HISTORIC AND DESIGN REVIEW COMMISSION

HDRC CASE NO: 2017-130
ADDRESS: 2037 W SUMMIT
LEGAL DESCRIPTION: NCB 1942 BLK 30 LOT 10
ZONING: R-6
CITY COUNCIL DIST.: 7
DISTRICT: Monticello Park Historic District
APPLICANT: Barbara Ancira
OWNER: Barbara Ancira/The Ancira Trust
TYPE OF WORK: Remove a side entry door and remove one window at the rear of the house
REQUEST:

2037 W. Summit Avenue

REAR ELEVATION - REMOVAL OF REAR WINDOW

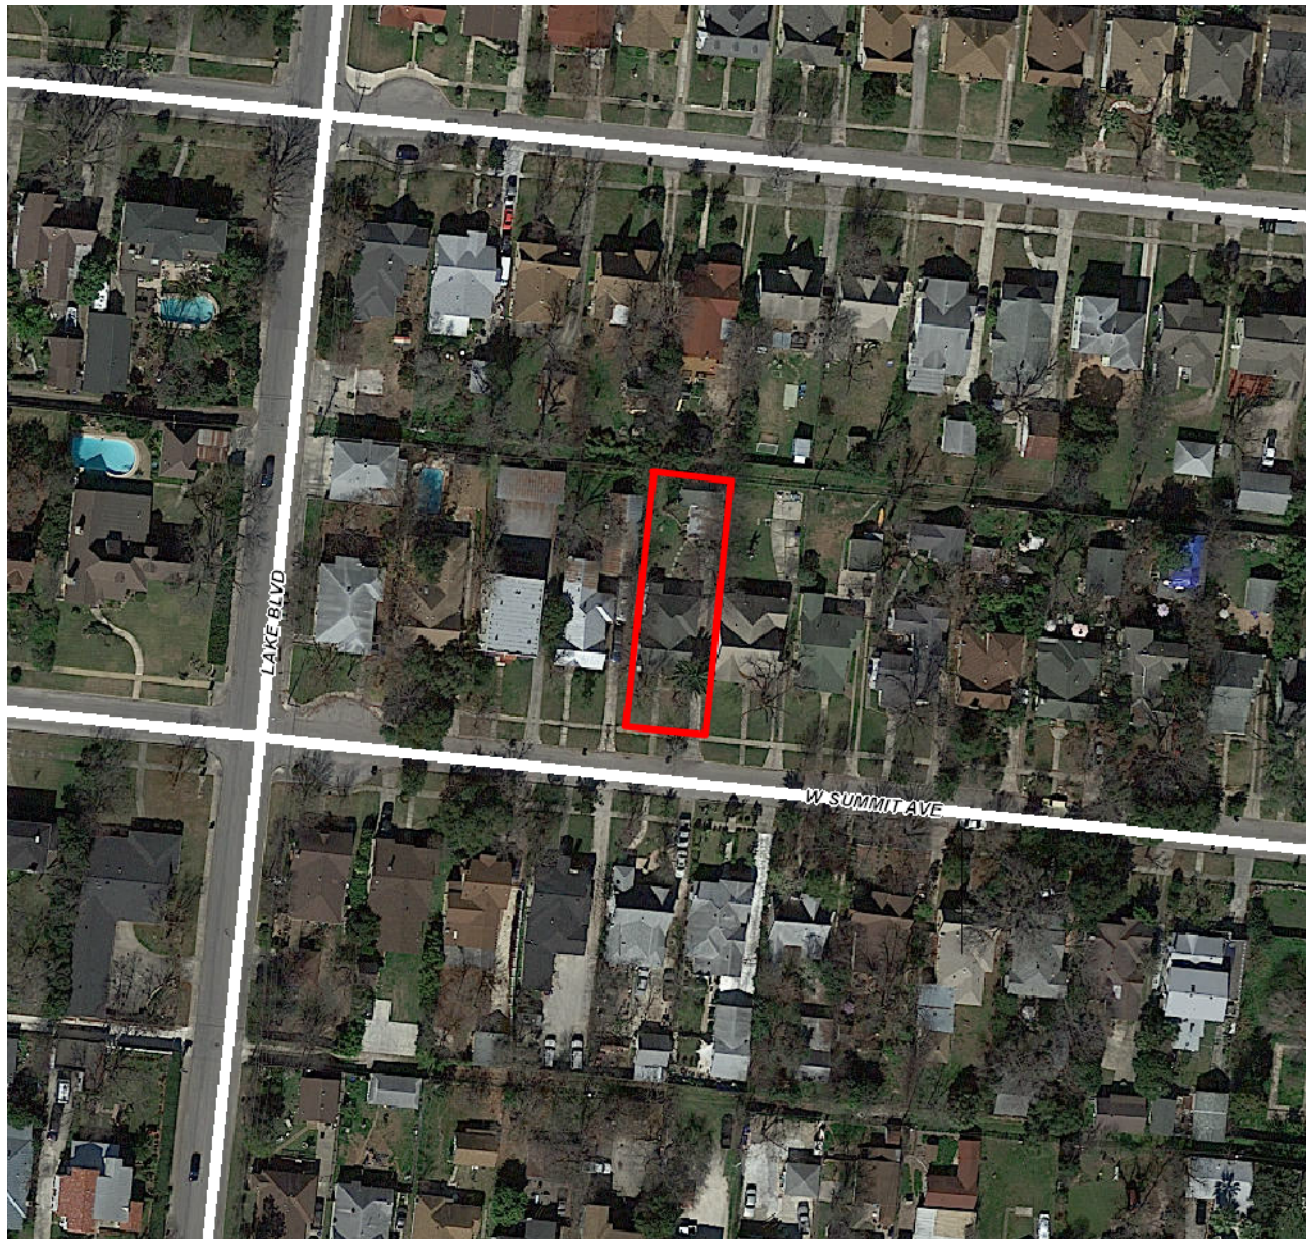
- a. The structure at 2037 W Summit Ave was constructed in 1931 with Craftsman style elements. It is a contributing structure in the Monticello Park Historic District. The applicant has requested approval to remove an existing side entry door and existing rear window, both to be filled with siding to match original existing wood lap.
- b. **EXISTING DOOR** – According the Historic Design Guidelines, the filling of historic door and window openings should be avoided. The existing side entry door does not appear to be original to the house and both its material and dimensions are incompatible with nearby historic openings and trim details. Staff finds the proposal to remove the door and fill with wood lap siding to match existing acceptable.
- c. **EXISTING WINDOW** - According the Historic Design Guidelines, the filling of historic door and window

openings should be avoided. The existing rear window opening, including its dimensions and materials, appear to be original to the house. Staff does not find the proposal to remove the window and fill the opening with siding consistent with the guidelines.

1. Staff recommends approval of the proposed door removal and siding installation based on finding b.
2. Staff does not recommend approval of the proposed window removal and siding installation based on finding c. Should the HDRC approve this request, staff recommends the applicant salvage original materials for donation.
